MINUTES FROM 8 NOVEMBER 1994 BASE REALIGNMENT AND CLOSURE TEAM
MEETING NTC ORLANDO FL
11/8/1994
ABB ENVIRONMENTAL

Subject: Minutes of the November 8/9 BRAC Clean-up Team (BCT) Meeting

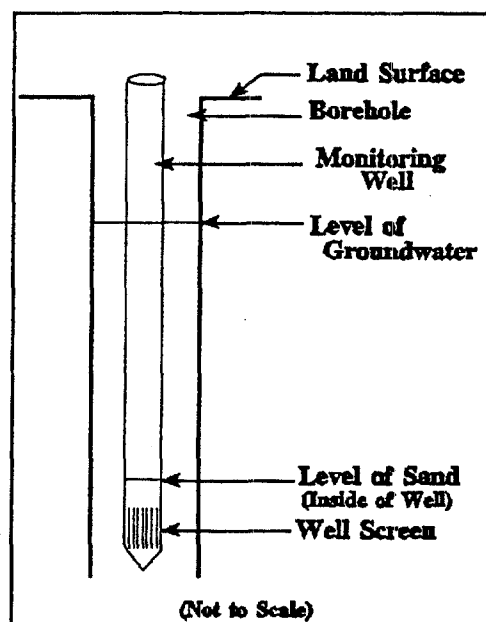
Fred Sloan initiated a discussion on the use of temporary wells or direct-push technology (DPT) methods for sample acquisition. An example, provided by Fred, is shown at right. The well, of either stainless steel or PVC construction, would be installed and sampled after allowing time for the groundwater to enter the well, through the sand pack. The well could then be removed and reused as appropriate. Fred indicated that this well installation and sampling technique has been used for many years by USEPA and, in addition to saving money, can be installed, sampled and removed in an hour's time (dependent upon local hydrological conditions obviously). It was agreed that the usefulness of this technique was primarily limited to two areas; for screening contamination plumes in order to determine optimal sampling locations or well placement, or for screening areas where there is no apparent source of contamination (screening being conducted based on anecdotal or hearsay information). Temporary wells in this latter scenario would be sufficient to ascertain the absence or presence of contaminants. The BCT agreed that during the review of the site screening plans, areas would be sought wherein the use of temporary wells or DPT for sample acquisition could be employed.
